UNITED STATES PATENT AND TRADEMARK OFFICE

Office Action Summary

10/516,532

DETAILED ACTION

Fig. 2A

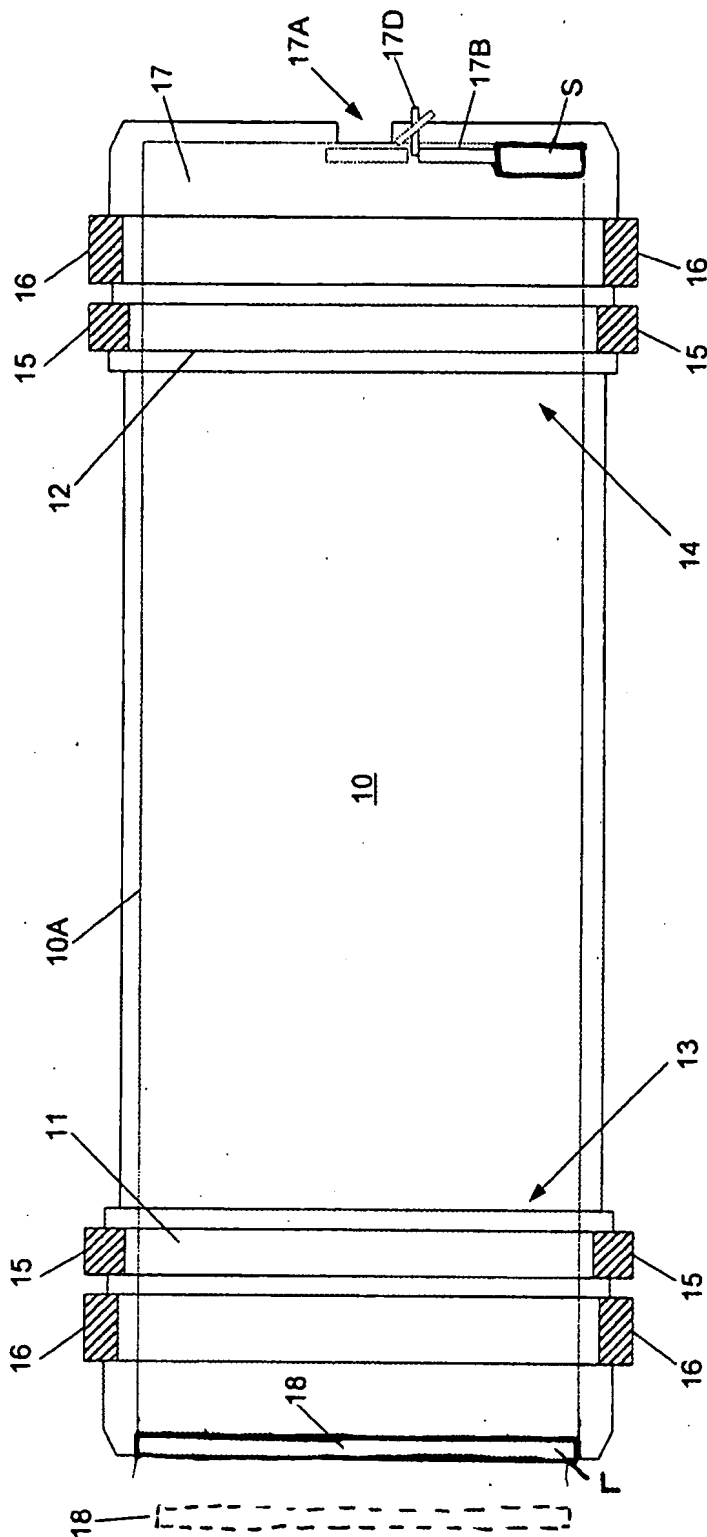
1. The proposed drawing correction of 6/6/07 has not been entered as containing new matter.

Element 18, U-shaped as seen in the Figure(s), previously indicated as an integral piece from the top reference(s) numeral 16 to the bottom reference(s) numeral 16 is now trifurcated. There are additional discrepancies.

With regard to page 11, second paragraph, the newly submitted Figure(s) shows no indication as to how the shutter is opened.

Do
Not
Enter
Ex Dillon
